**APPLICANT RESPONSE LETTER
AND
REVISED CONCEPT PLAN
JANUARY 26, 2024**

Re: Sakura East PRO Concept Plan Review Response Letter – **Updated to address Planning Commission comments**

Sakura East: JSP23-26
Wetland Review of PRO Concept Plan
MSG Project 2300844

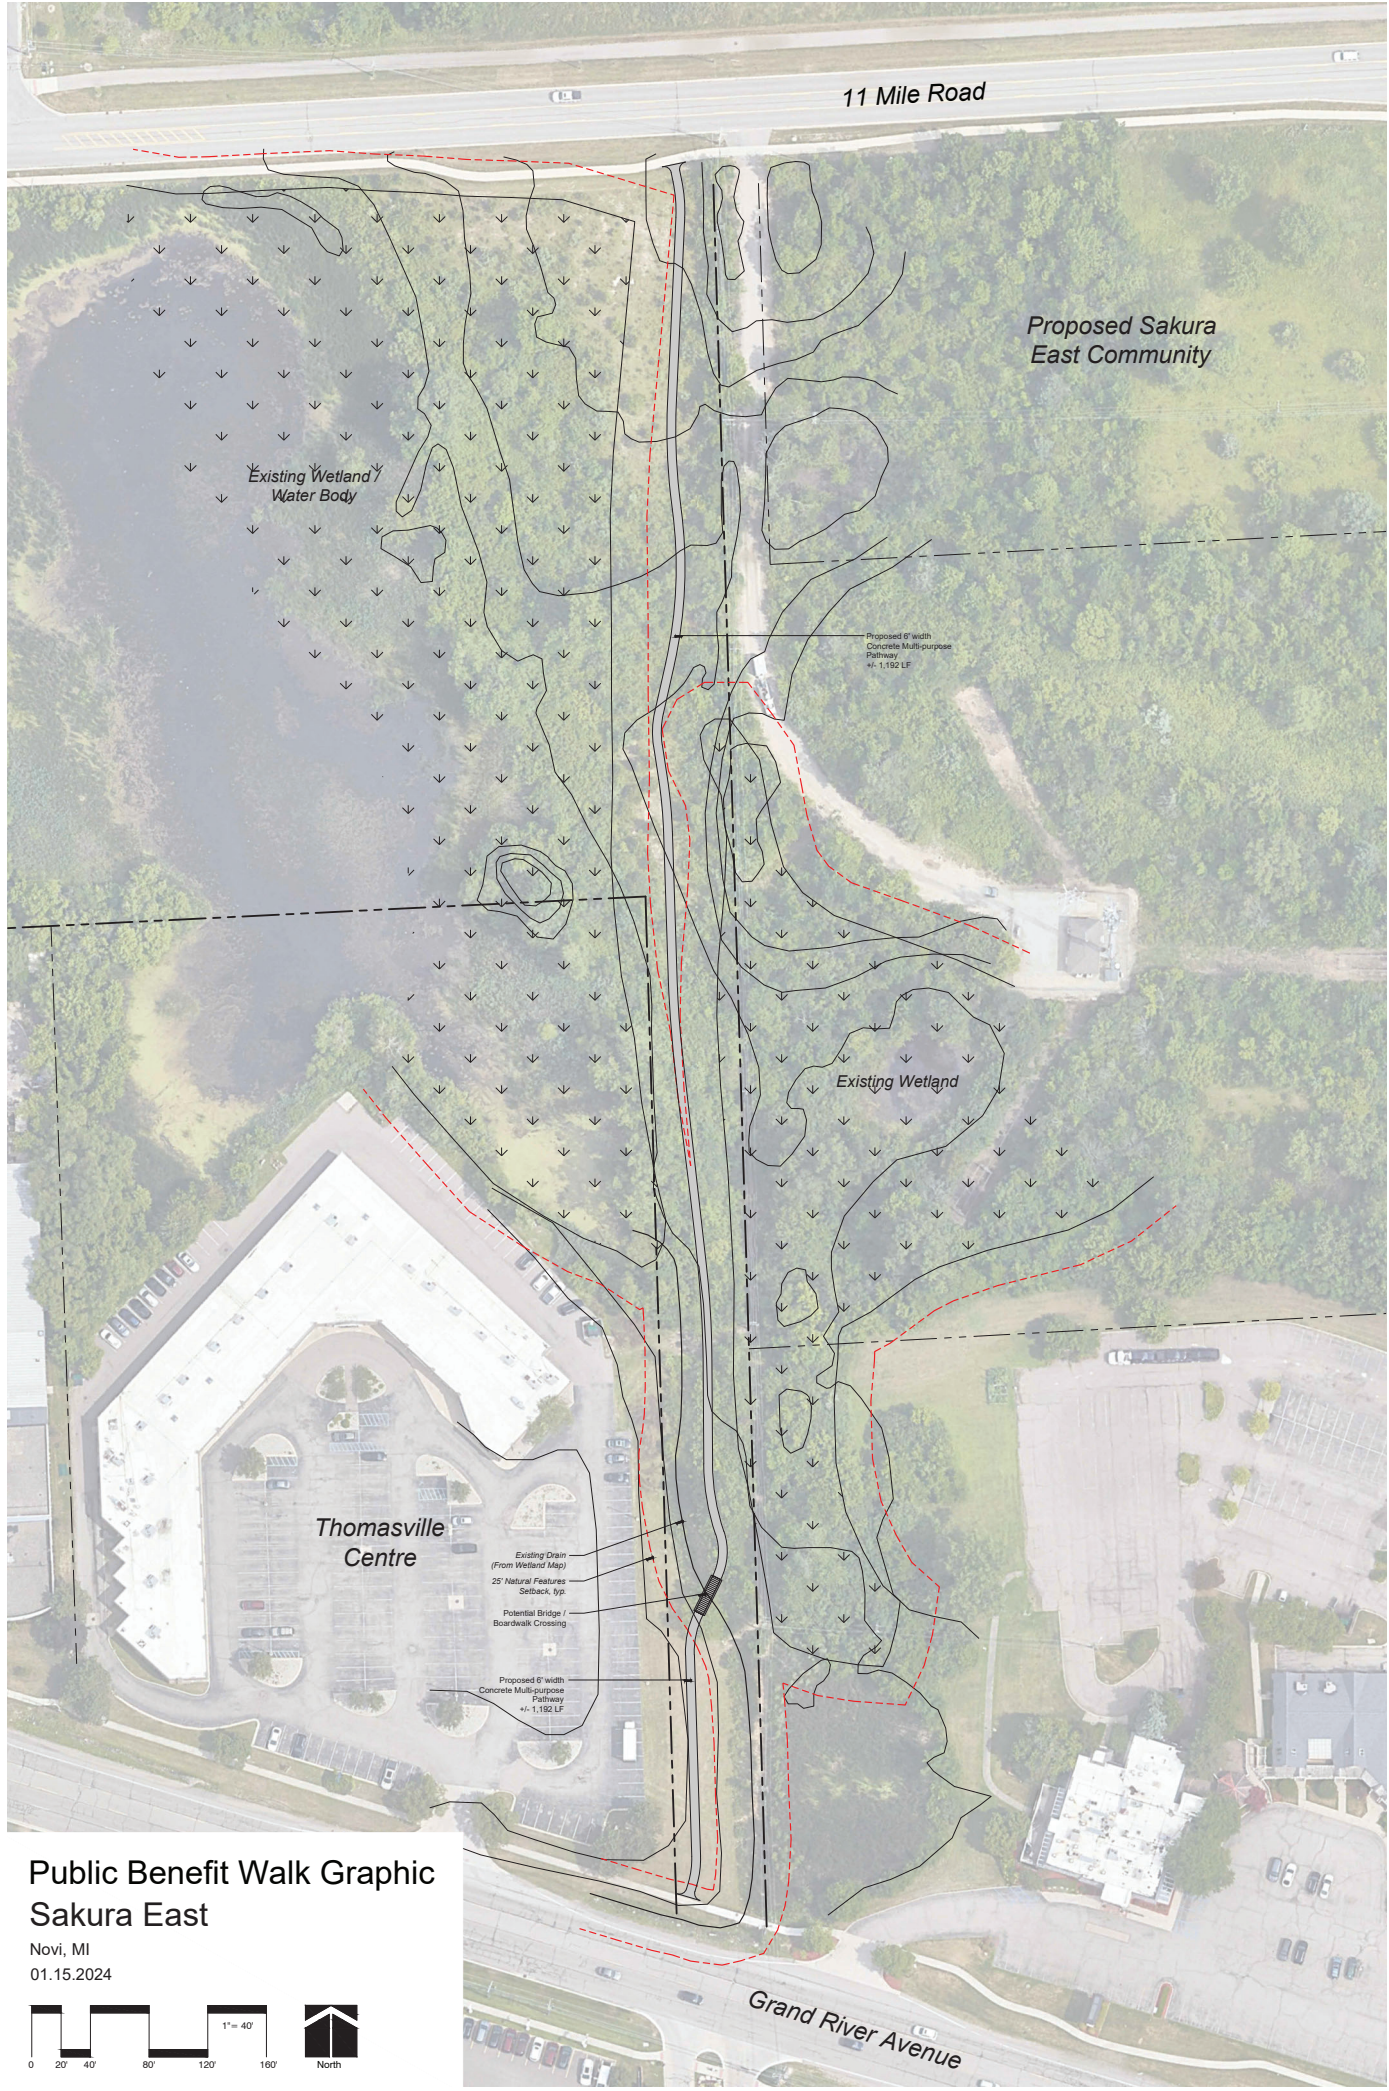
- 3. Provide details on usable open space and meet the Ordinance requirements without utilizing balcony space toward minimum calculations.**

We have added details for the internal usable open space areas, which have been added to three distinct open areas, to include a gathering area amenity with fire pit and string lighting, a focal seating garden amenity, and a multi-purpose amenity with turf for outdoor recreational opportunities. The provided usable open space of 13,813 square foot exceeds the requirement of 9,000 square feet by almost 50%, even without the addition of the private balcony areas which by Ordinance can also be included in the usable open area calculation, to address the Planning Commission's thoughts that it is important to exceed the usable open space without the balcony area included.

Required: 200 sf of Usable Open Space per Unit
	Proposed Units: 45
	Required: 9,000 sf
	Provided: 13,813 sf

sheet title:
Tree Preservation Plan

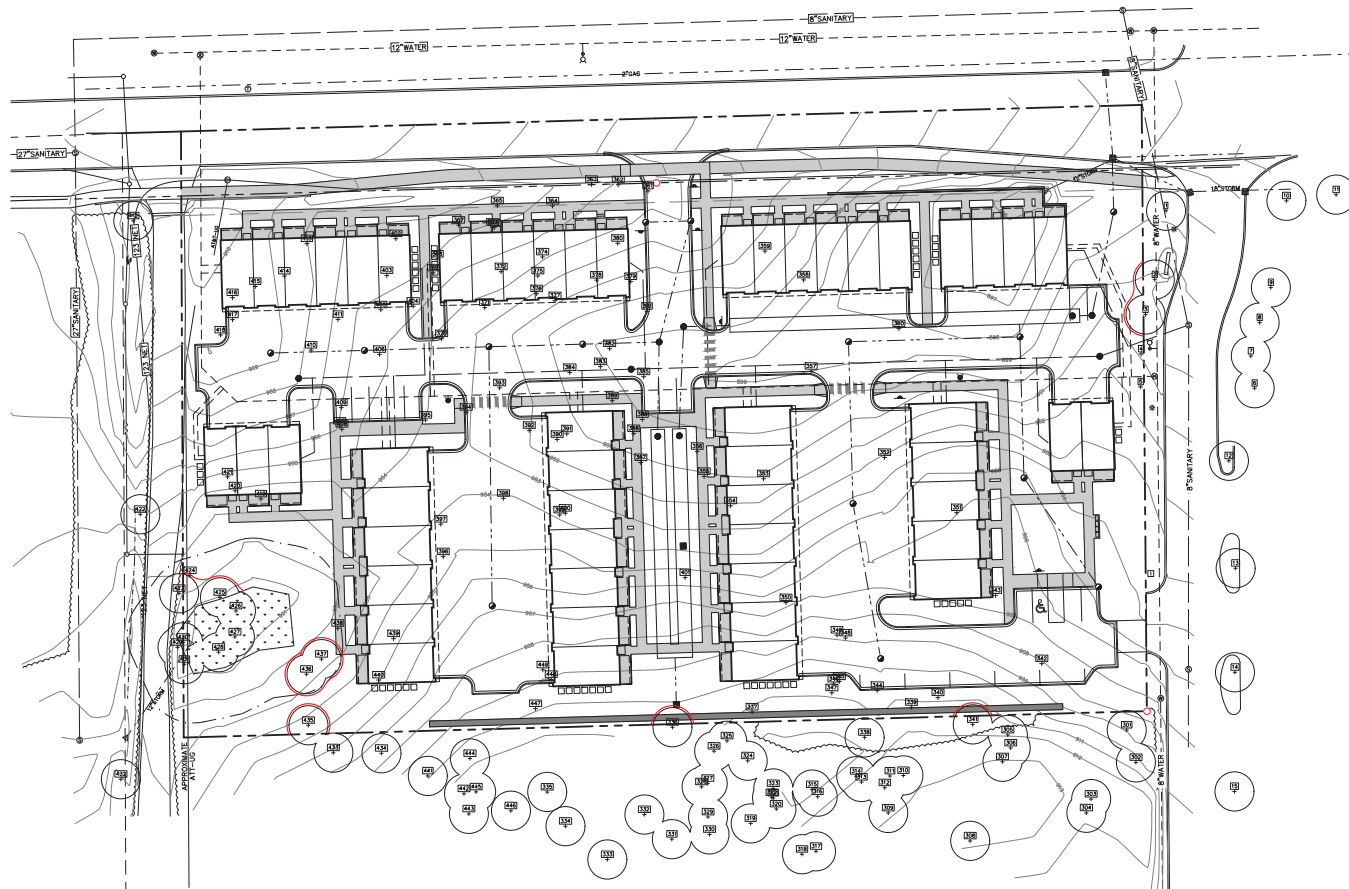
The Plan and Report depict one wetland onsite that is 0.03 acres. MSG visited the Site on November 6, 2023 to evaluate the wetland limit lines depicted on the Sheet L-3 of the Plan. The observed conditions at the project site generally consisted of vacant, mostly wooded land. Wetland delineation markers (labeled pink ribbon) were observed that generally corresponded to the perimeter of Wetland 1. Wetland 1 was observed to be forested wetland. **MSG does not agree with the delineation of Wetlands 1 as depicted on the Plan and flagged in the field. Based on MSG's assessment of Site conditions, the boundaries of Wetland 1 should be extended up to the off-Site access road and include trees 423, 424, 436, and 437.**

Figure 1: Current Zoning

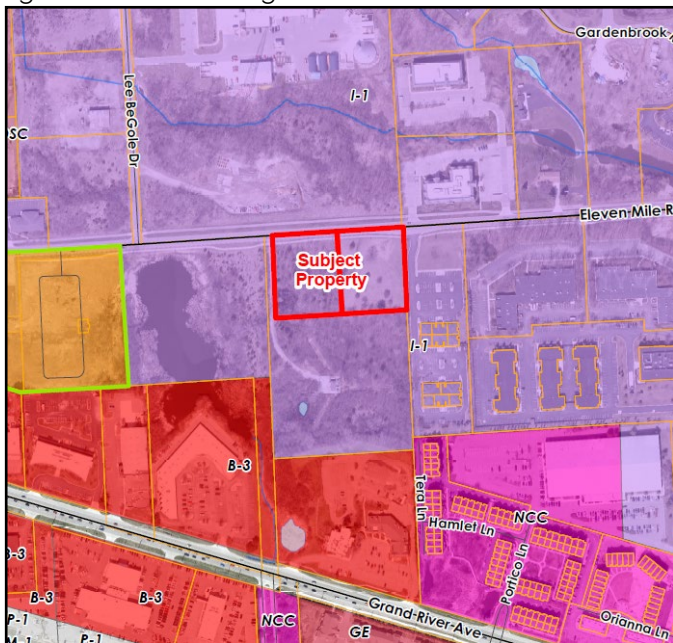
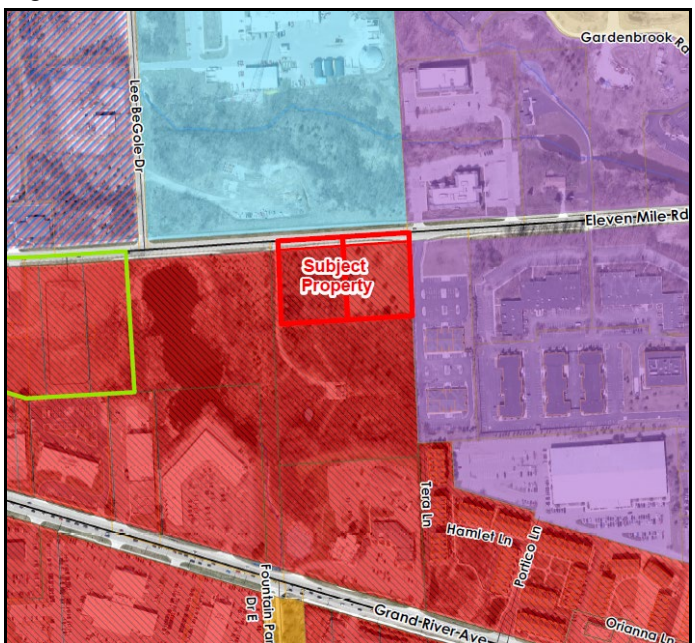
The proposed residential use would be surrounded on all sides by industrially zoned properties. There is no obvious connection to the larger Sakura Novi development, except for the sidewalk along 11 Mile Road and identical townhouse product type to be developed. The lack of contiguity between the projects is a significant barrier to justifying the proposed rezoning. Another barrier could be the completion of the planned road extension of Lee BeGole Drive down to Grand River, which preliminary designs have shown to be located just west of the subject property. In addition,

locating residential uses here would constrain the future development of each of the parcels surrounding it. Existing uses in the area may present undesirable conditions for new residents of the development, potentially creating a situation of incompatible land uses. The applicant has also not provided enough buffer/screening from industrially zoned properties. The public benefit to including this additional property also requires further definition by the applicant/developer.

PHOTOGRAPHS

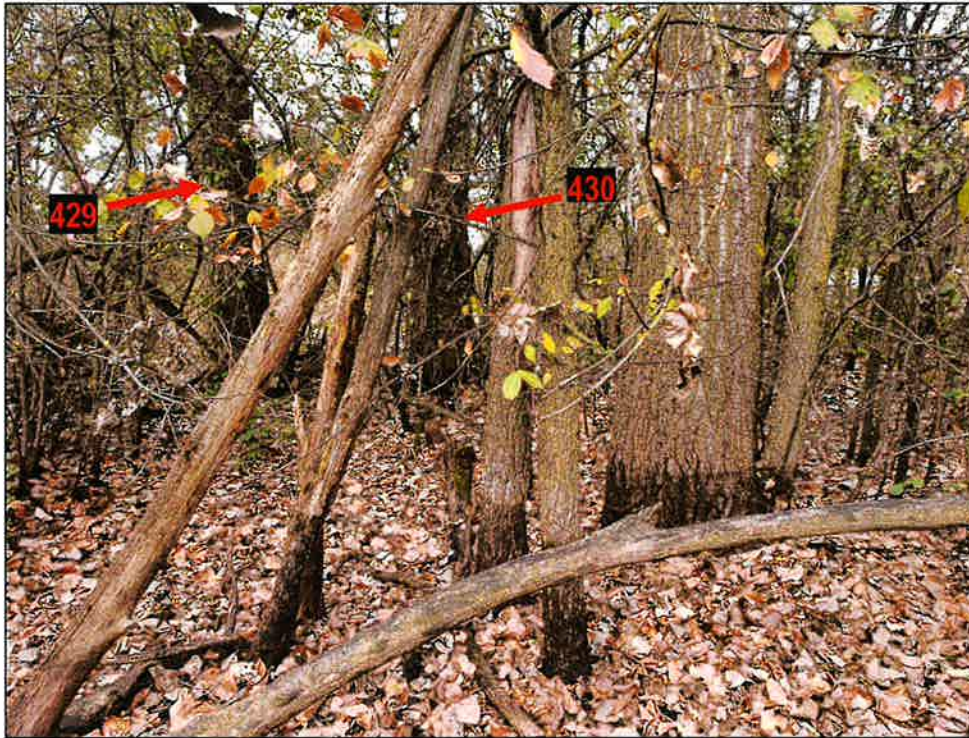
Photo 1: View of Wetland 1 with trees 430 and 429 outside of delineated wetland in background, facing west. Note water staining on tree 430.

Photo 2: View of wetland vegetation (reed canary grass and grey dogwood) outside of delineated wetland area near tree 436, facing north.
